TURKEY POINT PLANT UNIT NO. 3

TURKEY POINT PLANT UNIT NO. 4

ATTACHMENT TO LICENSE AMENDMENTS

SAFETY EVALUATION BY THE OFFICE OF NUCLEAR REACTOR REGULATION
RELATED TO AMENDMENT NO. 94 TO FACILITY OPERATING LICENSE NO. DPR-31
AND AMENDMENT NO. 88 TO FACILITY OPERATING LICENSE NO. DPR-41
FLORIDA POWER AND LIGHT COMPANY
TURKEY POINT PLANT UNIT NOS. 3 AND 4
DOCKET NOS. 50-250 AND 50-251

FIGURE 6.2-1 OFFSITE ORGANIZATION FOR FACILITY
MANAGEMENT AND TECHNICAL SUPPORT

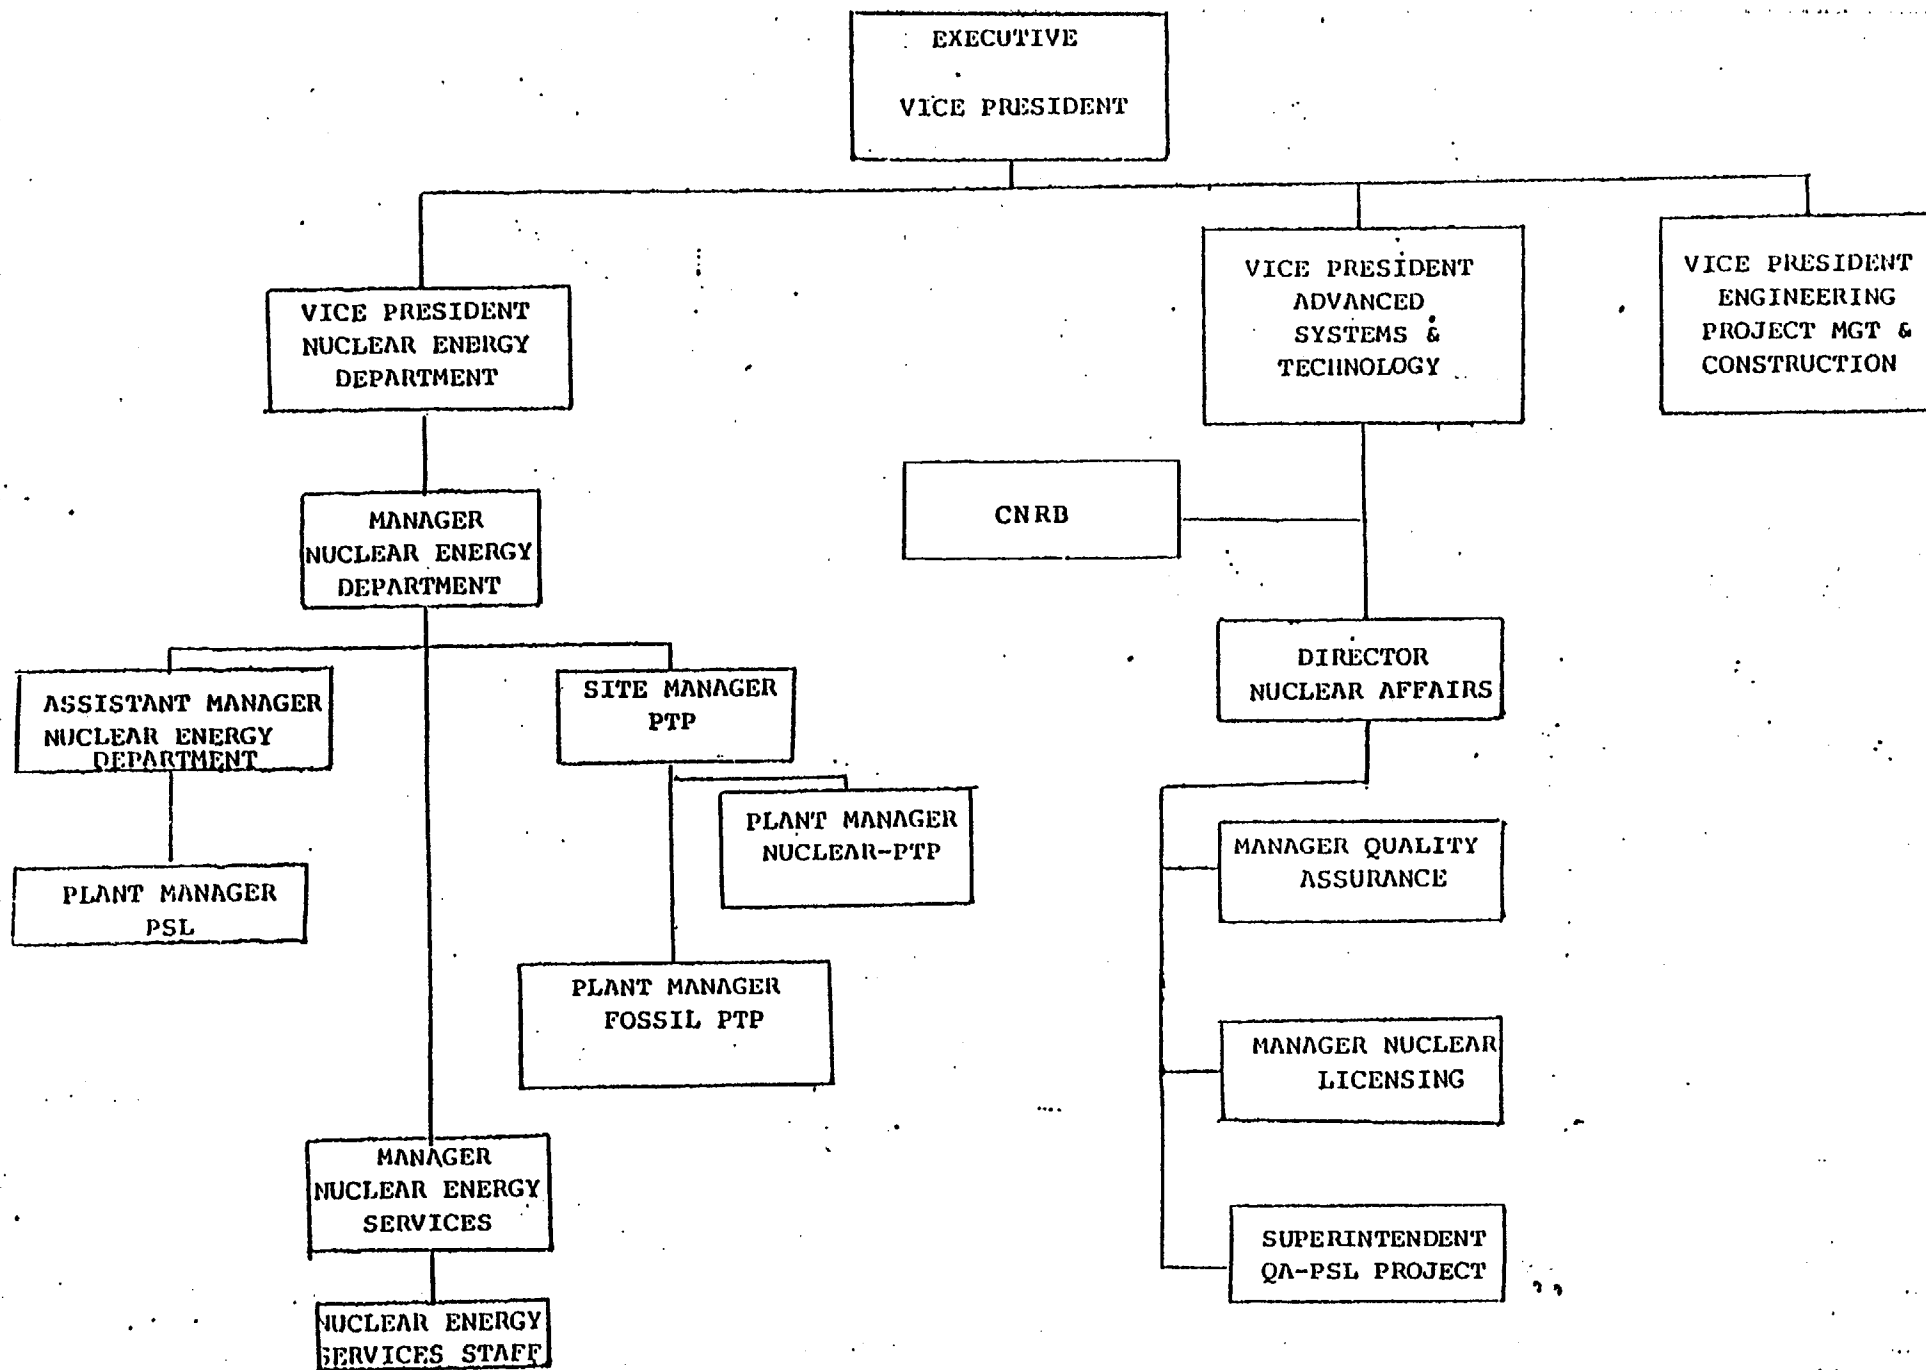
The licensee proposes to modify Figure 6.2-1, "Offsite Organization for Facility Management and Technical Support" to show that a Nuclear Energy Department (NED) has been formed to manage the nuclear activities that were previously managed by the Power Resources Department. The new NED is headed by a Vice President who reports directly to the FPL Executive Vice President. Reporting to the new Vice President-NED is a Manager-NED, a position that was previously titled Manager-Power Resources-Nuclear and that previously reported to the Vice President-Power Resources. The Site Manager and the Manager-Nuclear Engineering Services (title changed from Manager-Power Resources Nuclear Services) and a new position titled Assistant Manager NED report to the Manager-NED.

We conclude that the organization structure changes as discussed above does not diminish FPL's ability to safely operate the Turkey Point Units 3 & 4 and the proposed modifications to Figures 6.2-1 and 6.2-2 to reflect these changes are acceptable.

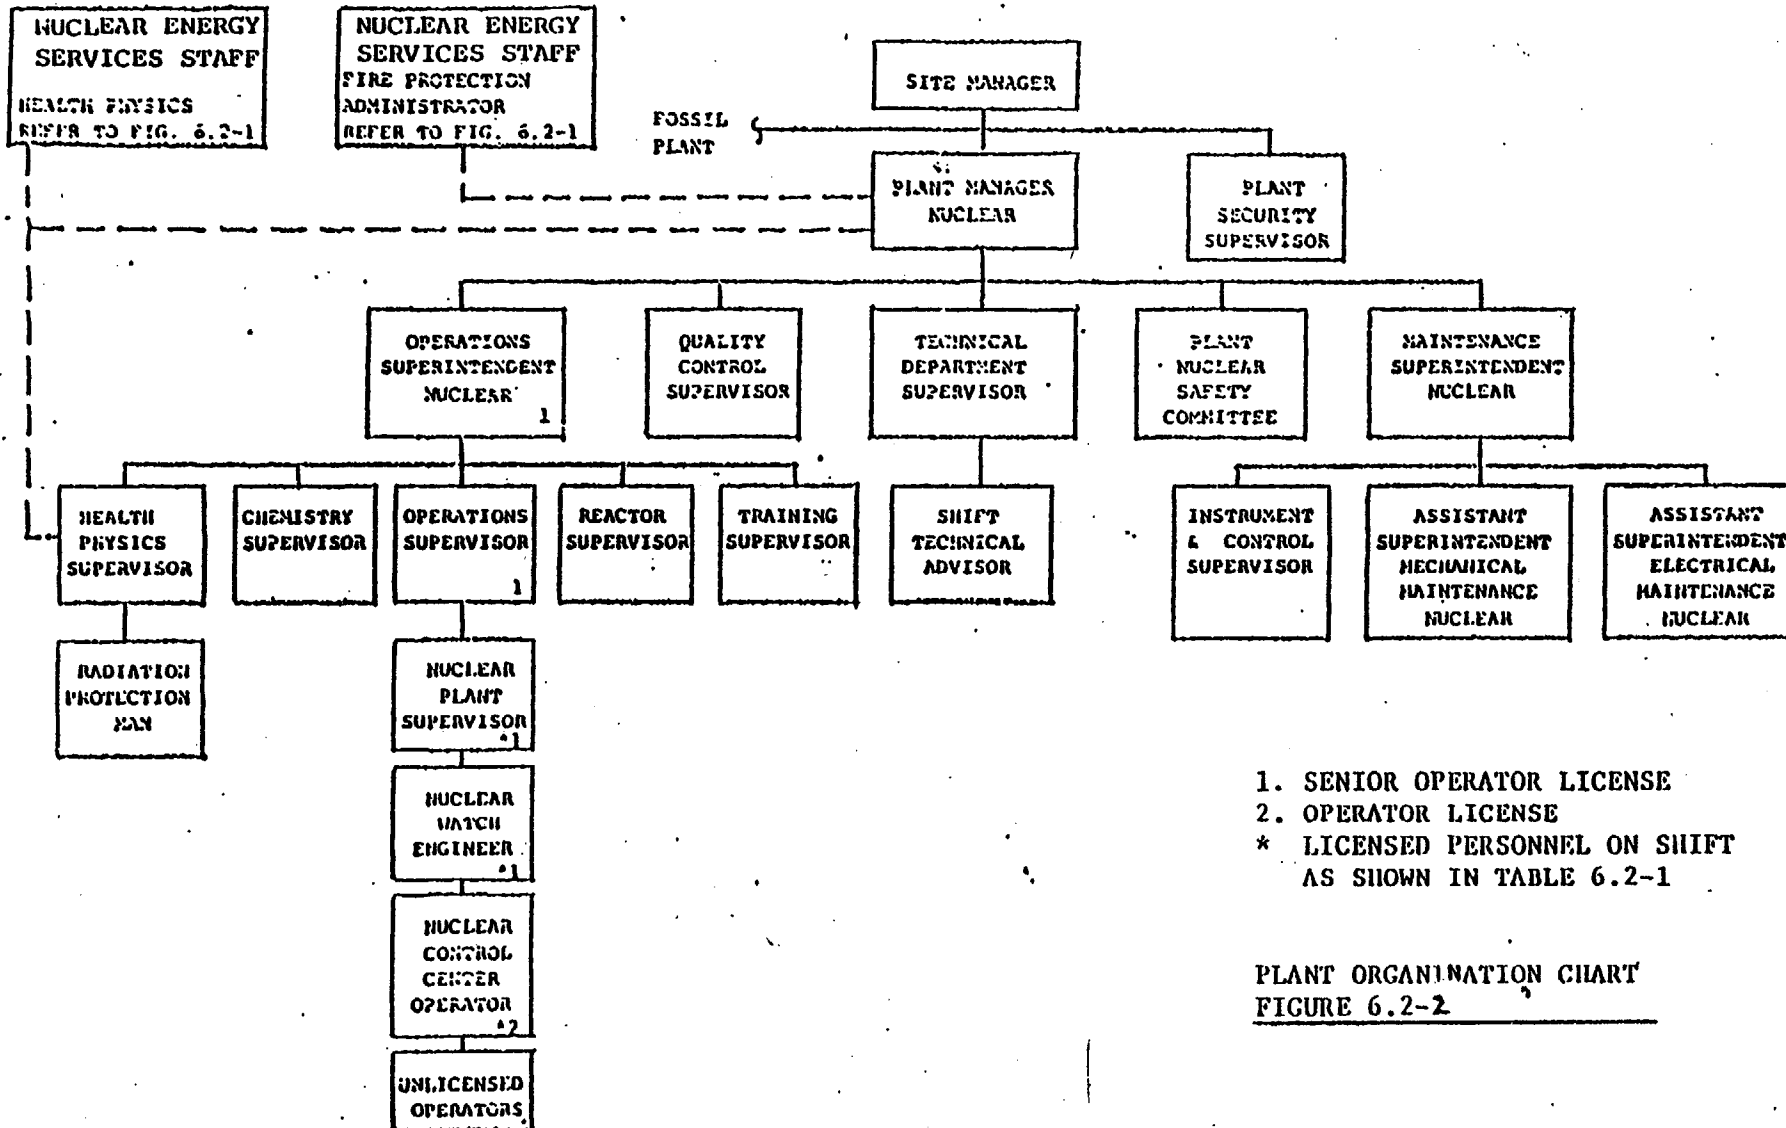
The licensee also proposed to modify Figure 6.2-2 to reflect the title changes in the offsite organization. The titles in the two boxes currently listed as Power Resources Staff will change to Nuclear Energy Services Staff.
